RENESAS TECHNICAL UPDATE

Product Category	MPU&MCU		Document No.	TN-H8*-A401A/E	Rev.	1.00
Title	Correction of errors in the H8SX/1648, H8SX/1648A, H8SX/1648L, H8SX/1648G, and H8SX/1648H Group Hardware Manual		Information Category	Technical Notification		
Applicable Product	H8SX/1648, H8SX/1648A, H8SX/1648L, H8SX/1648G, and H8SX/1648H Group	Lot No.	Reference Document	H8SX/1648, H8SX/1648A, H8SX/1648L, H8SX/1648G, and H8SX/1648H Group Hardware Manual (REJ09B0365-0200)		
		All lots

(1) Page 568, DTCER description in figure 12.1, Block Diagram of DTC

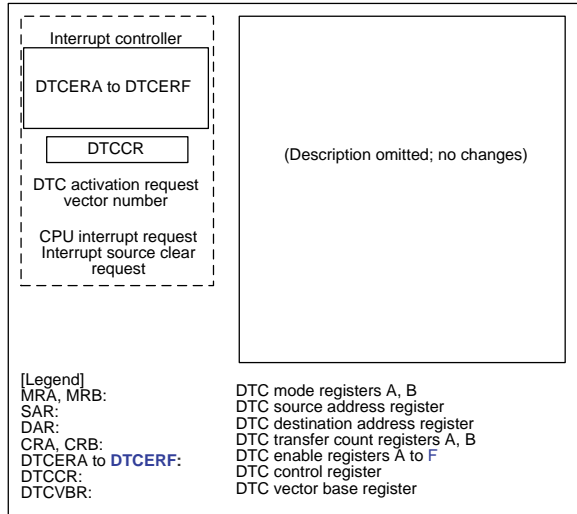
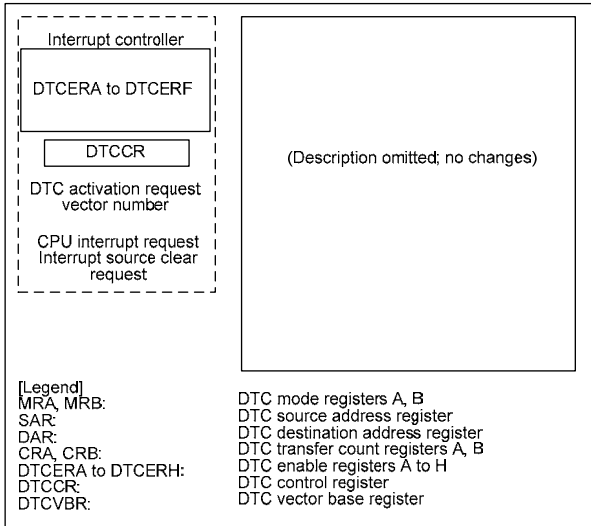
Section 12 Data Transfer Controller

Deletion of DTCERG, and DTCERH in DTCER
